PLANNING COMMISSION

Meeting Date: April 23rd, 2026

AGENDA ITEM: 6.A

REQUEST: Site Plan Review; Preliminary Major Condominium (Open Space Development Option)

PRELIMINARY BASIS OF DESIGN:

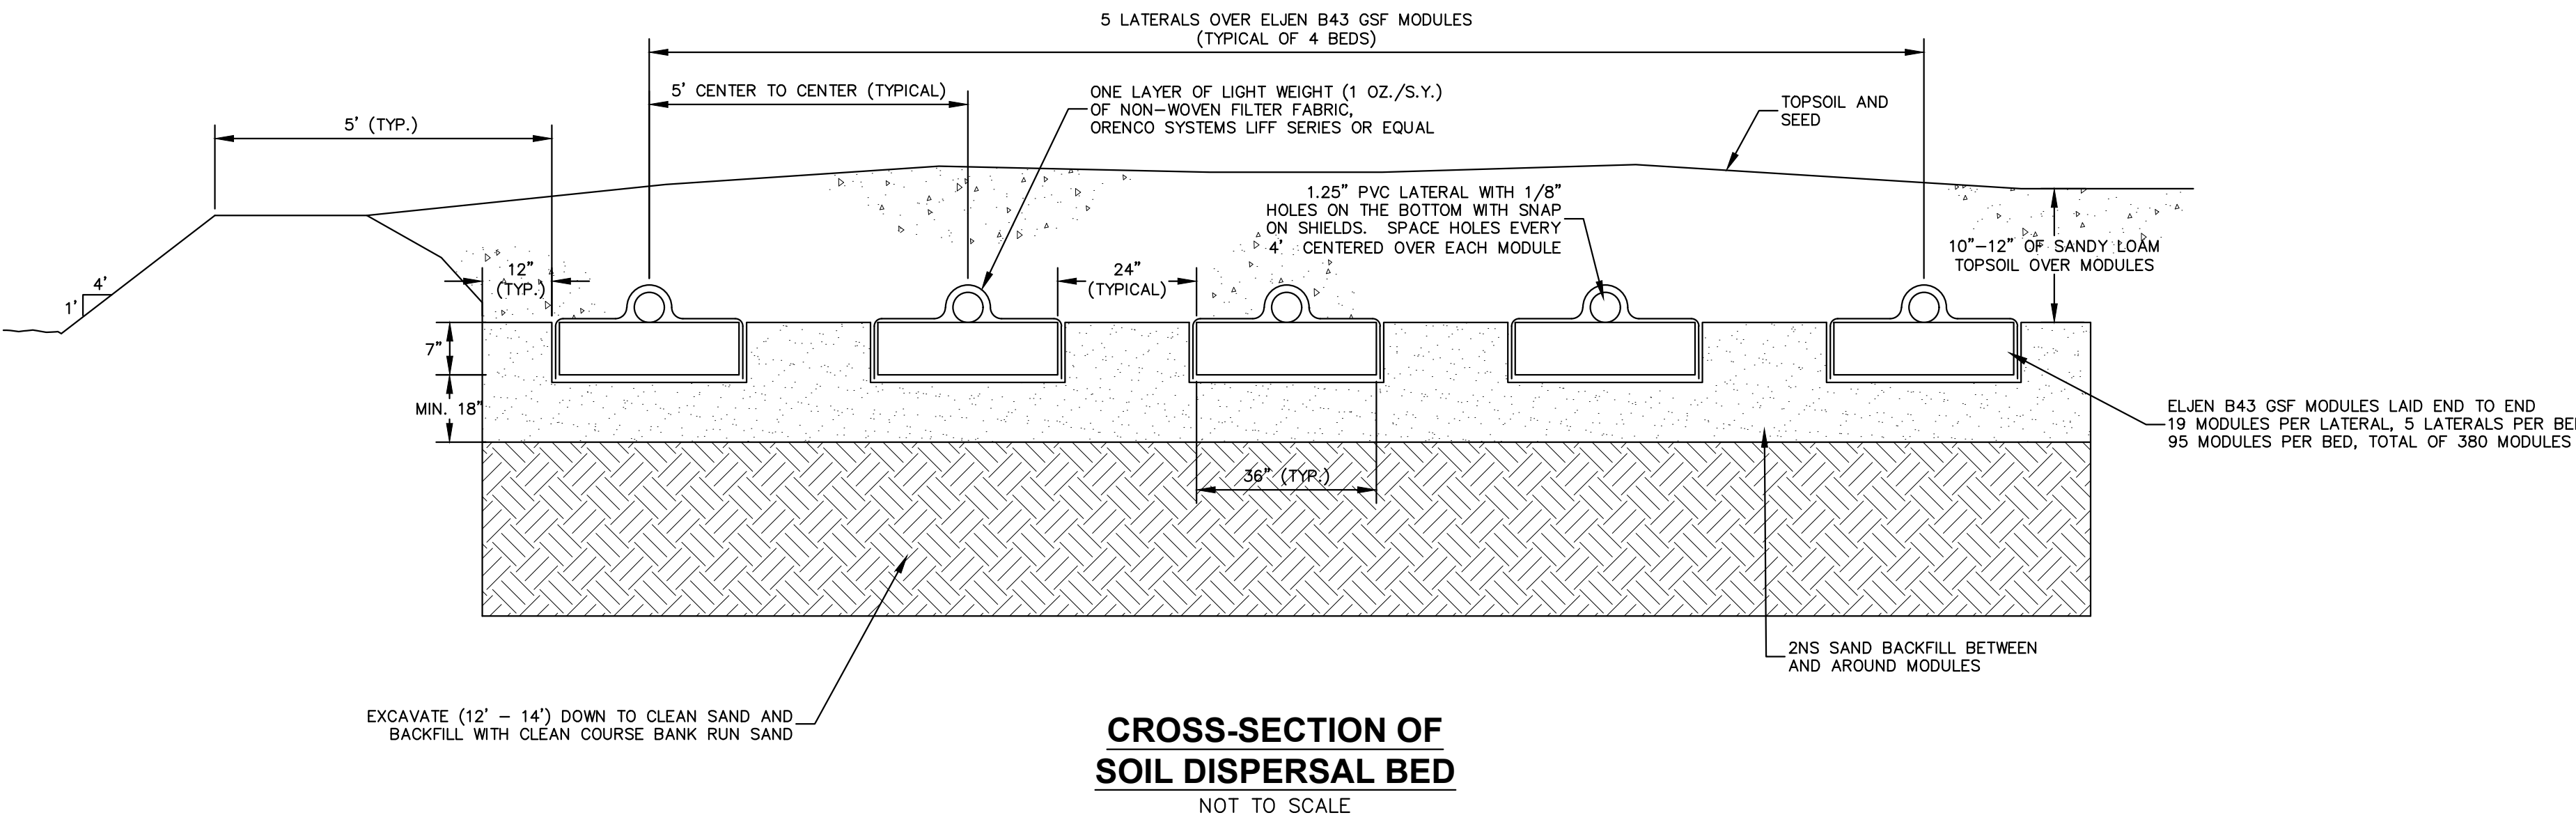
Does not meet standard. The site plan indicates that there will be two large detention basins to the west of the proposed homes, and one smaller detention basin to the east, which is an existing drainage course. There will be four private drainage easements, three of which will be between lots on the west side of the street and one which will be between lots on the east side of the street. The applicant has also specified that all existing field tile drains within the 100-foot isolation buffer for the drain fields will be relocated to be outside of the isolation area.

Undetermined, condition recommended. The applicant is proposing a private community septic system to serve the 30 residential lots, which will each have their own individual well. Although the proposed plans have no bearing on the BGUA's ability to provide public services, the Township Engineer's review dated 04/15/2026 indicates several deficiencies which must be addressed through updated plan sets. Final plans must be reviewed and approved by the Township Engineer and the Kent County Health Department.

PHOTOMETRIC PLAN

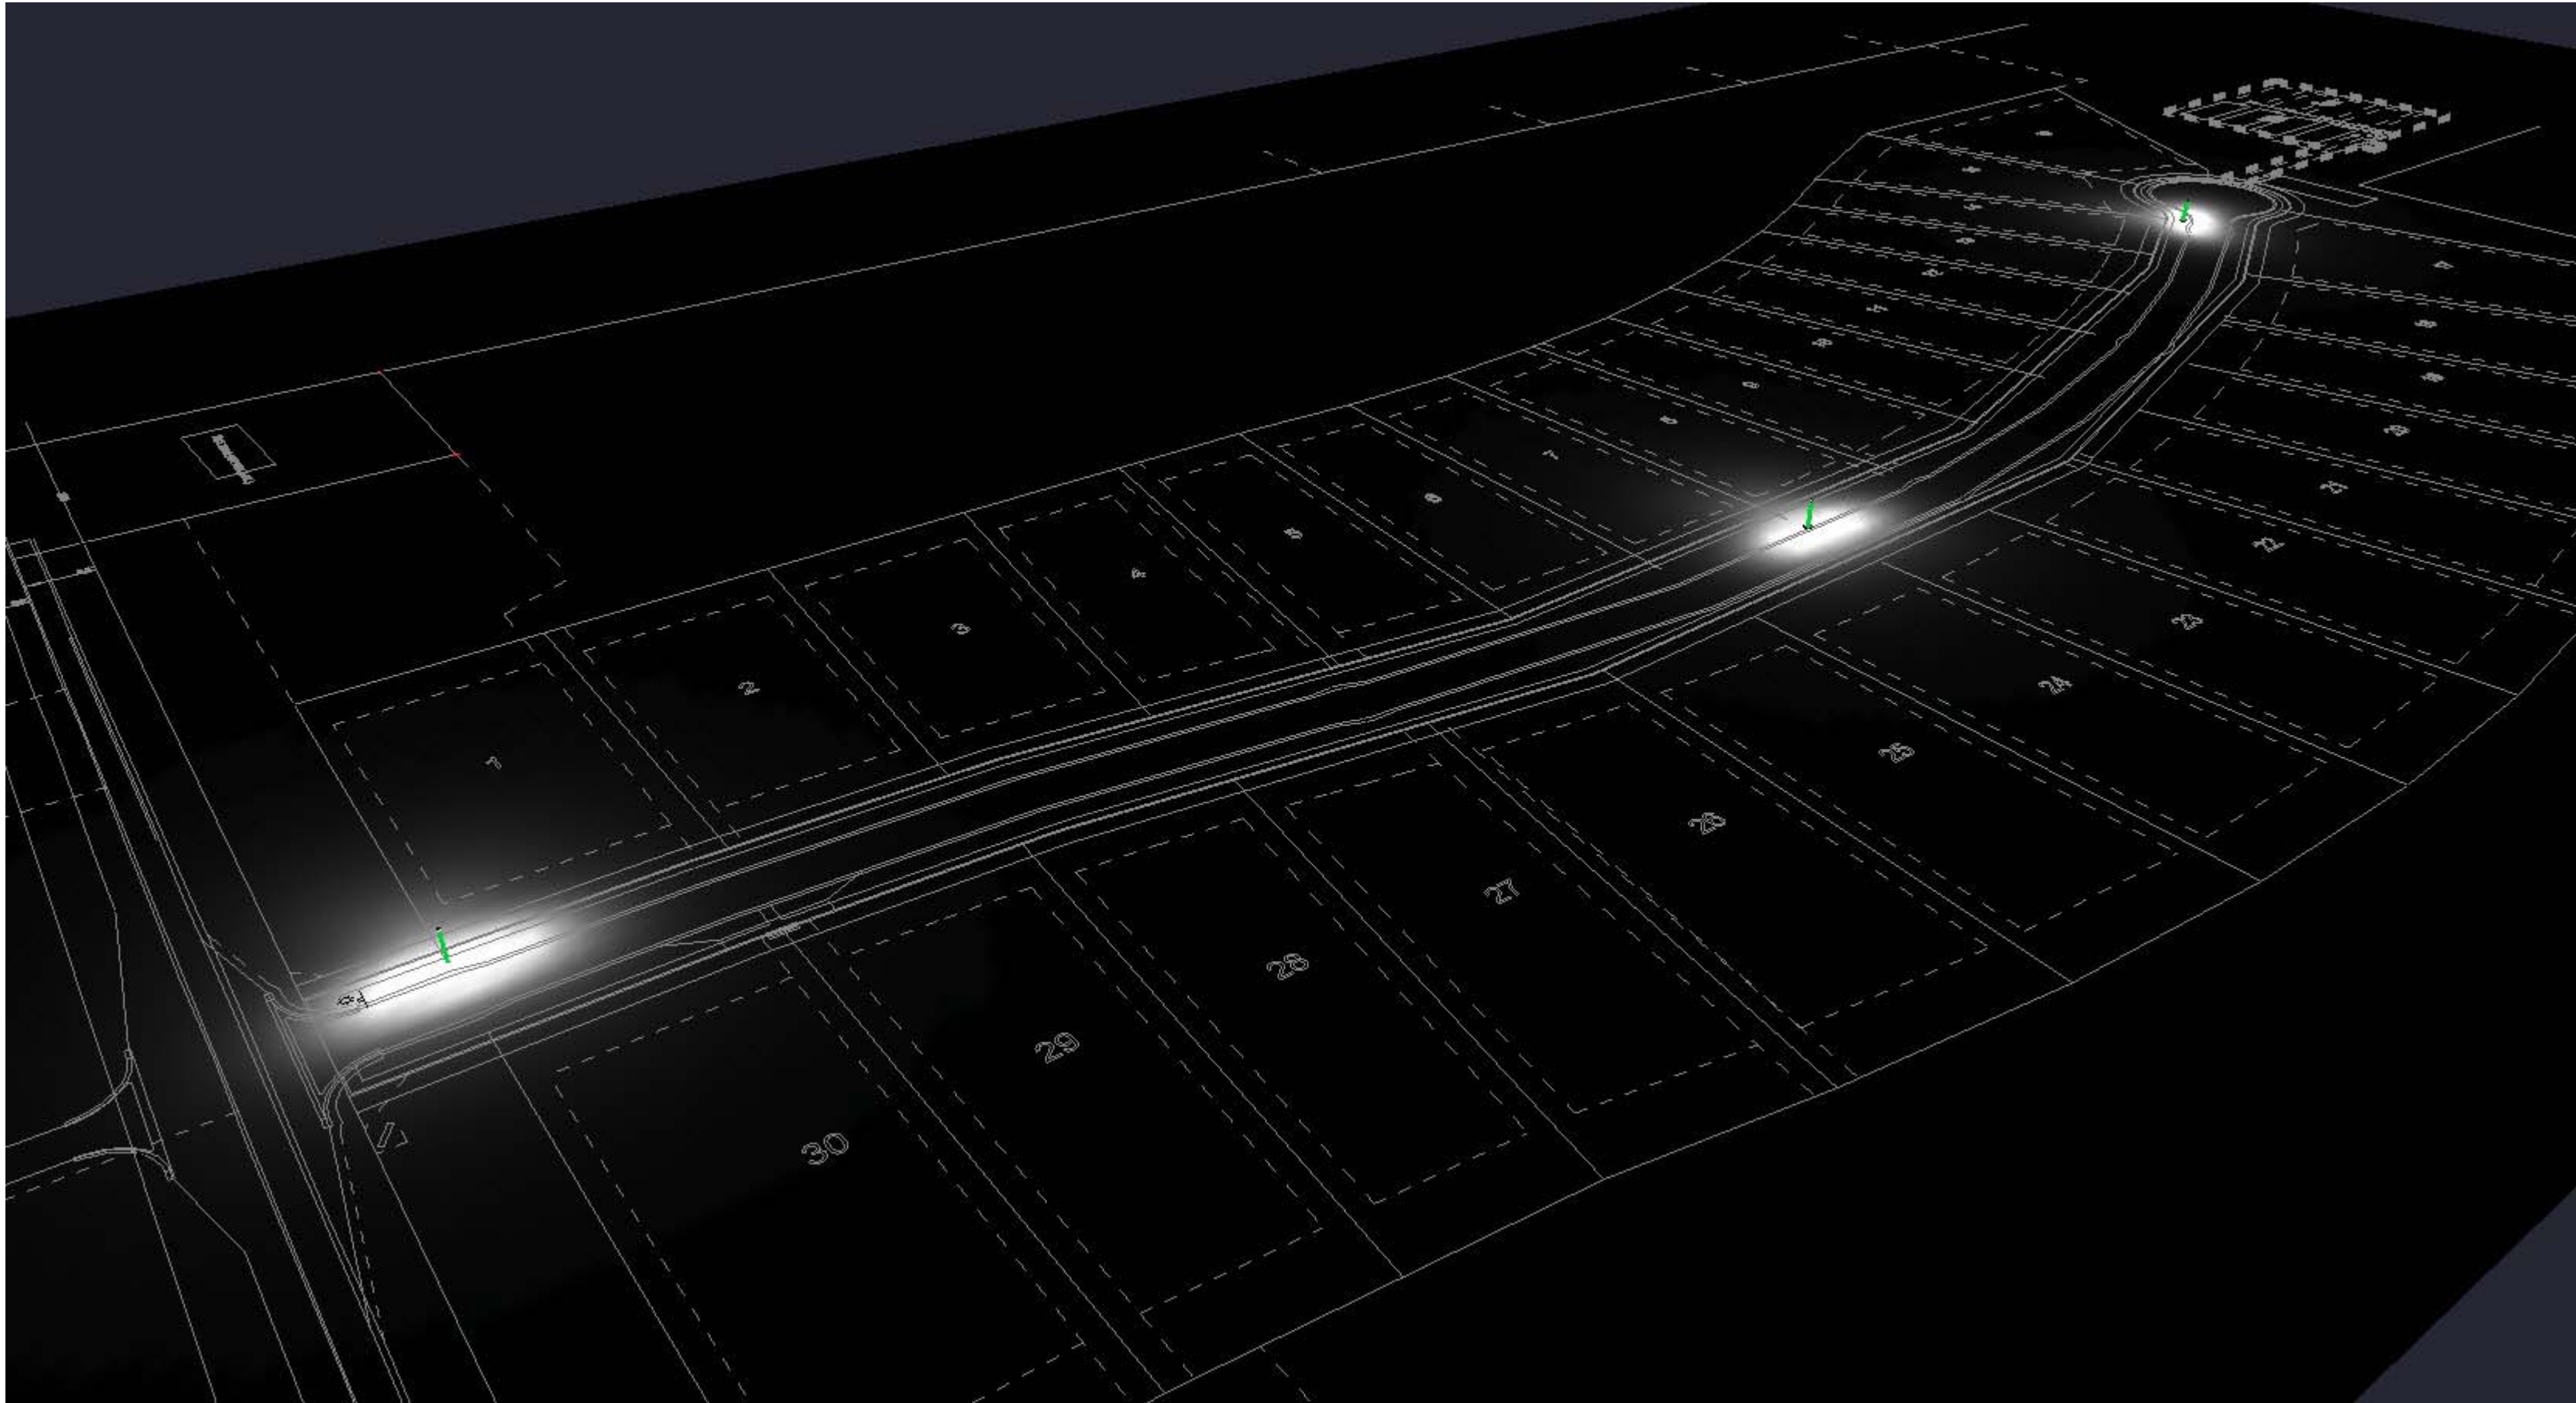
Meets standard. The site plan indicates that three light poles will be constructed along the right-of-way, which are planned to have a mounting height of 15 feet. The provided photometric plan dated 4/7/2026 demonstrates compliance with the requirements of Chapter 19; all fixtures are fully cut-off and down lit, color temperature will not exceed 2,700K, and the lighting plan maintains 0 fc at property lines.
